Economic Commission for Europe**Inland Transport Committee****World Forum for Harmonization of Vehicle Regulations****Working Party on Passive Safety****Sixty-second session**

UN Regulation No. 29 (Cabs of commercial vehicles)**Proposal for Supplement 4 to the 03 series of amendments to
UN Regulation No. 29 (Cabs of commercial vehicles)****Submitted by the expert from Germany***

I. Proposal

Figure 1
Front impact test and front pillars impact test
The cab is mounted on the vehicle

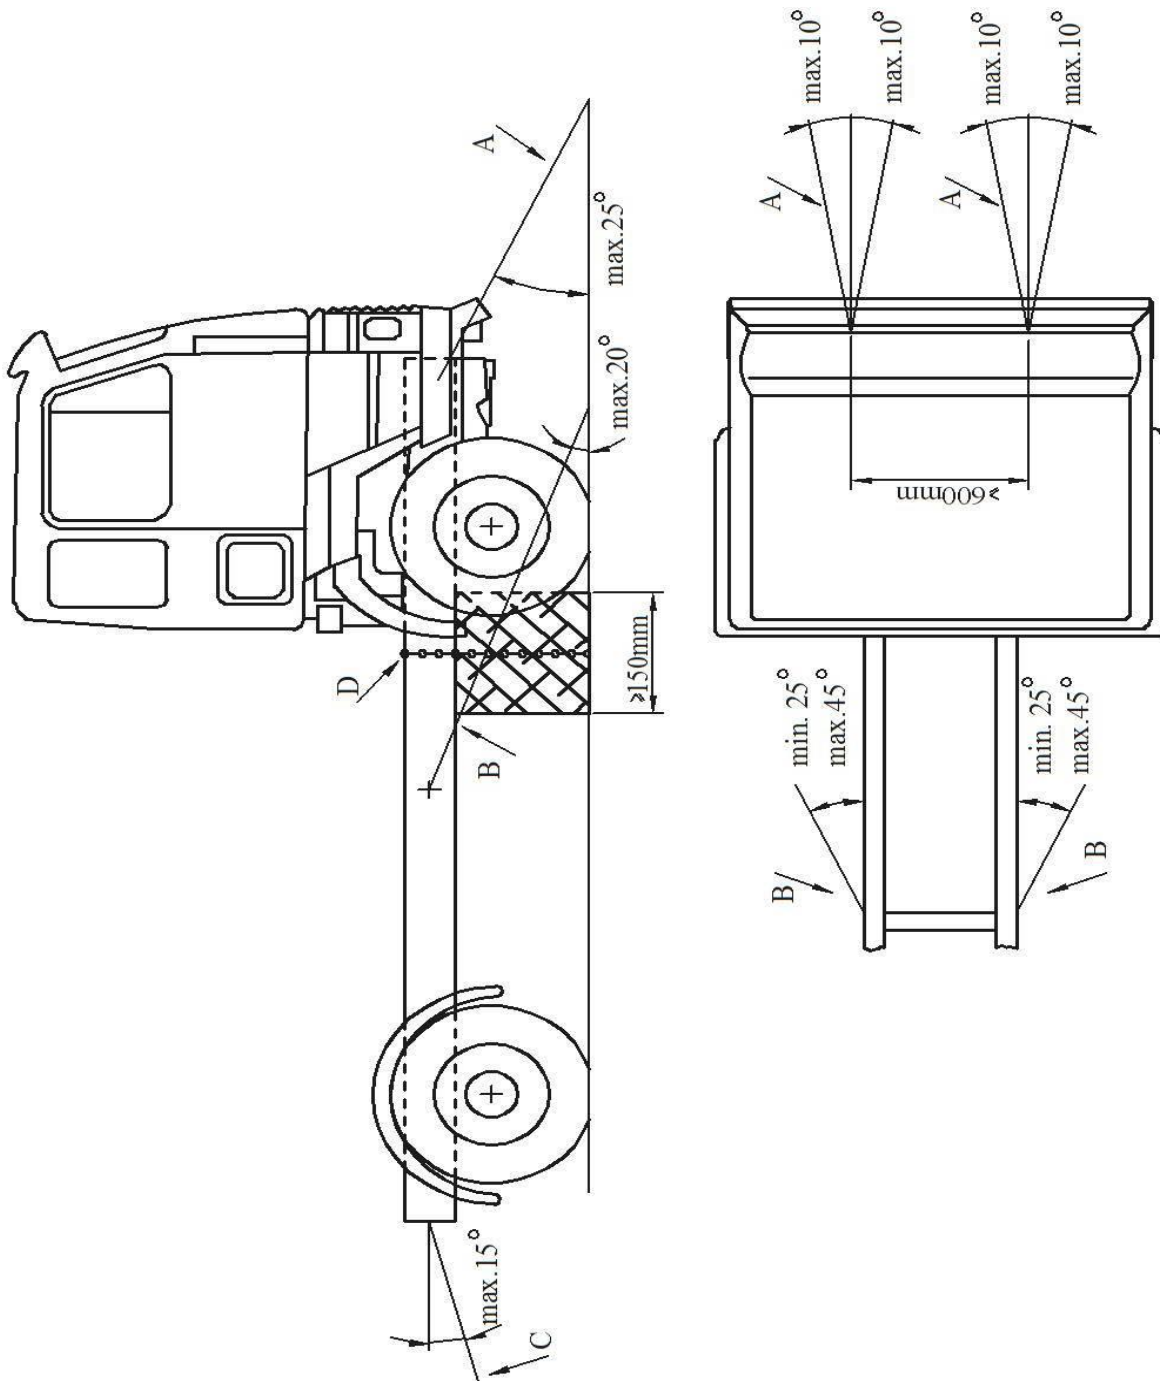
Test A shall be applied to a cab mounted on the vehicle as described under paragraph 1.
- 2.1. **Lateral attachment**

Lateral movement shall be limited by chains or ropes B attached to the chassis frame symmetrically in relation to its longitudinal axis. The points of attachment to the chassis shall be not more than 5 m and not less than 3 m from the front of the vehicle. The chains or ropes shall when tensioned form a downward angle of not more than 20° with the horizontal and their projection on a horizontal plane shall form an angle of not less than 25° and not more than 45° with the longitudinal axis of the vehicle (see figure 1 below).
3. Front pillars impact
- 3.1. Cab mounted on the vehicle (~~see fig. 1~~).

Lateral movement shall be limited by chains or ropes B attached to the chassis frame symmetrically in relation to its longitudinal axis. The points of attachment to the chassis shall be not more than 5 m and not less than 3 m from the front of the vehicle. The chains or ropes shall when tensioned form a downward angle of not more than 20° with the horizontal and their projection on a horizontal plane shall form an angle of not less than 25° and not more than 45° with the longitudinal axis of the vehicle (see figure 1 below).
- 3.2 Cab mounted on a frame

Figure 2 Roof strength test
The cab is mounted on the vehicle

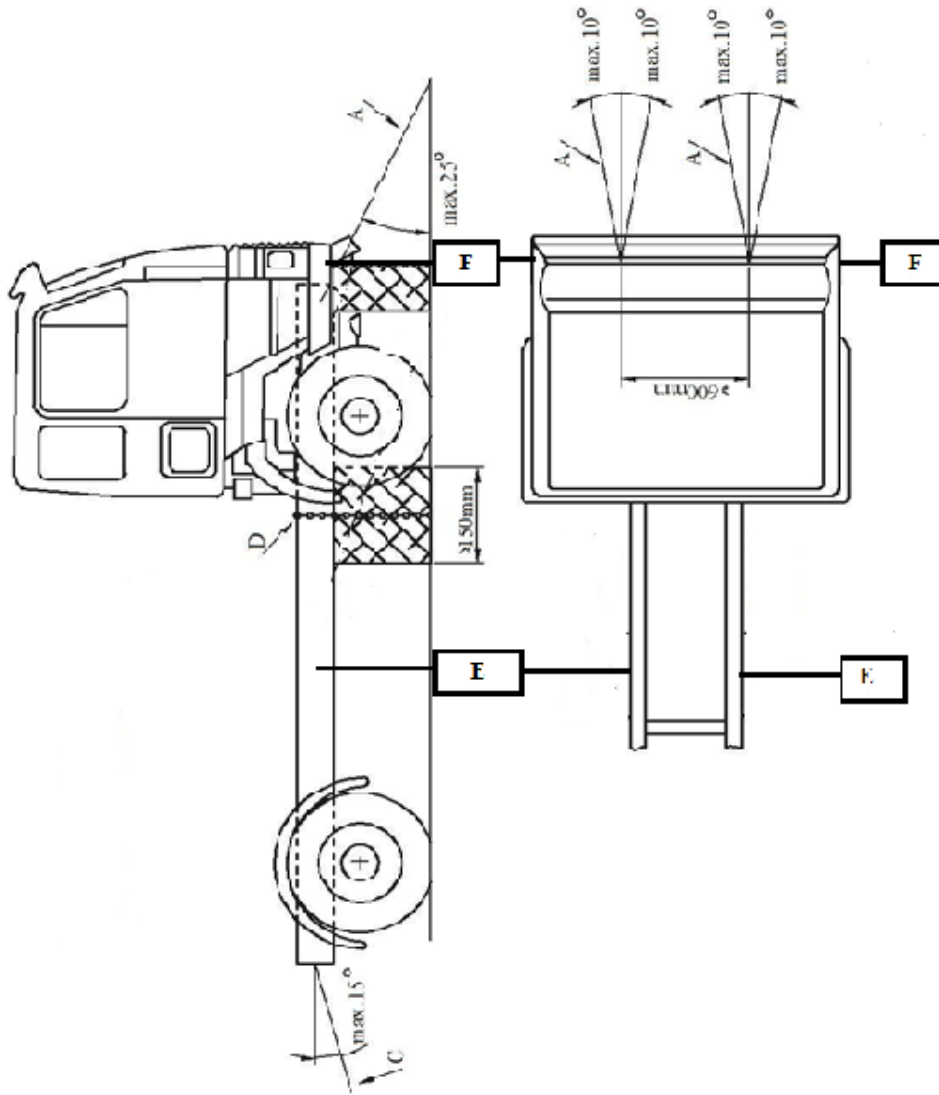
4.1.1. **Blocking of the chassis frame**

Notwithstanding paragraph 1.3 an additional support shall be placed under both sides of the longitudinal members of the chassis frame's front end.

4.1.2. **Lateral attachment**

Lateral movement shall be limited by chains or ropes E and F attached to the chassis frame symmetrically in relation to its longitudinal axis.

The points of attachment of chains or rope E to the chassis shall be not more than 5 m and not less than 3 m from the front of the vehicle.

The points of attachment of chains or rope F to the chassis shall be between the centre of the front axle and the front of the vehicle.

The chains or ropes shall when tensioned form a downward angle of not more than 20° with the horizontal and their projection on a horizontal plane shall form an angle $90^{\circ} \pm 5^{\circ}$ with the longitudinal axis of the vehicle (see figure 2 below).
